4no. Tree branches to be trimmed back in line with metal fence to accommodate cabin walkway at first floor

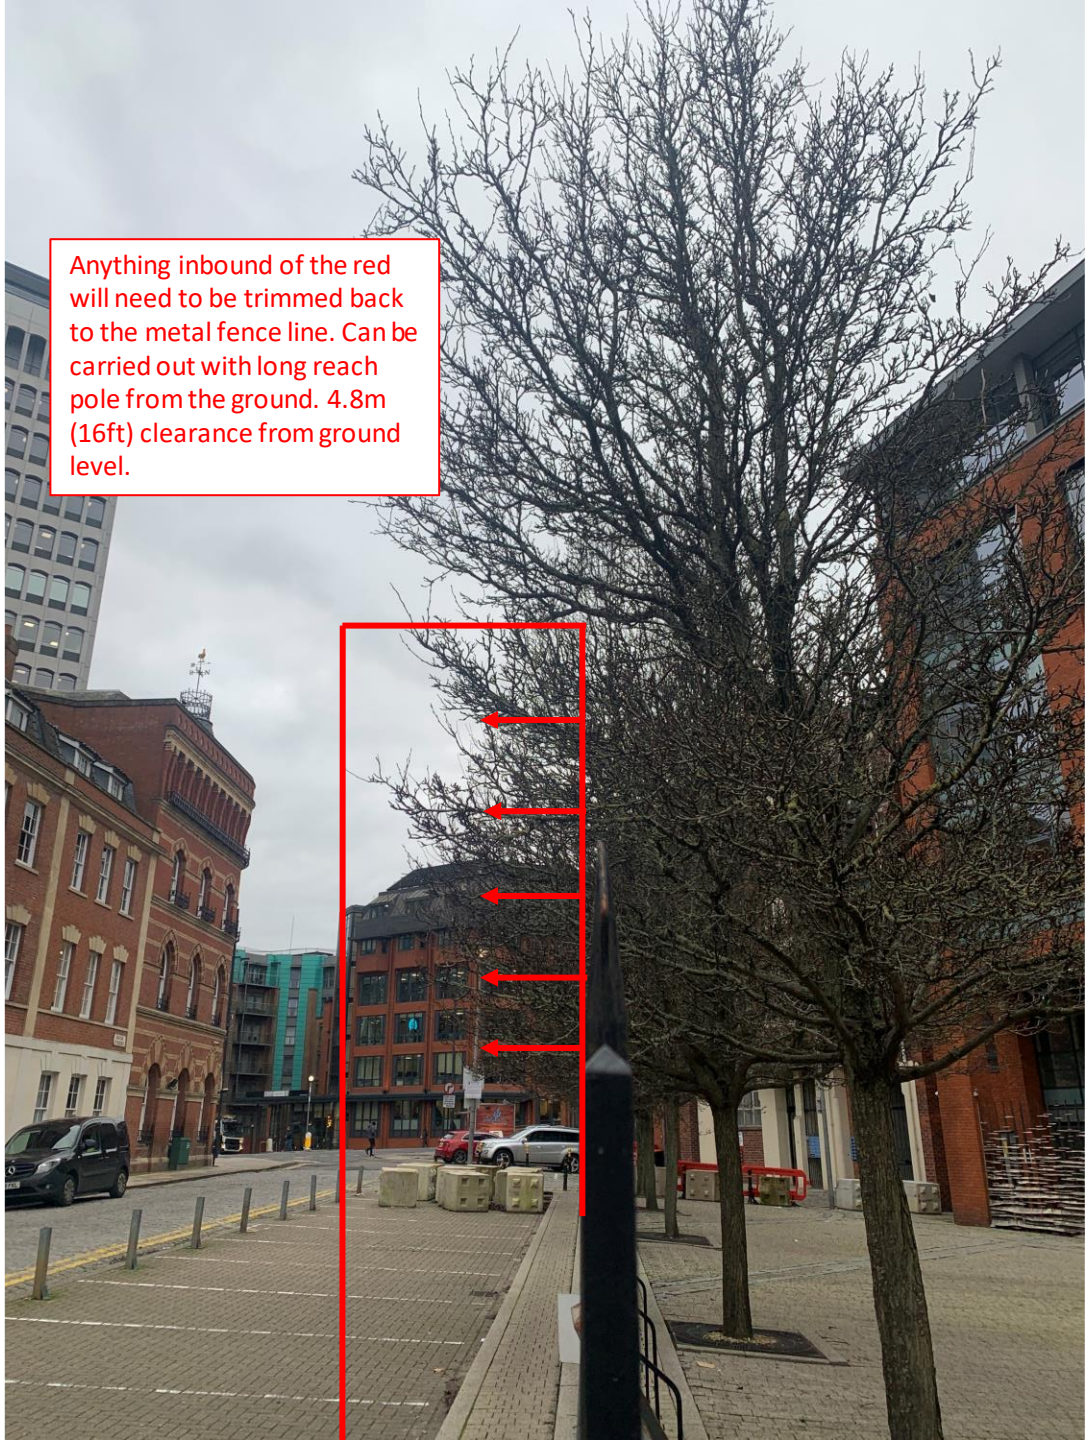
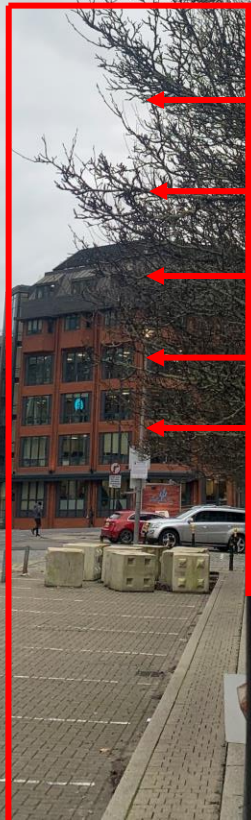
Anything inbound of the red will need to be trimmed back to the metal fence line. Can be carried out with long reach pole from the ground. 4.8m (16ft) clearance from ground level.

Approximate zone requiring trimming

Tree that will require trimming back for raised walkway installation
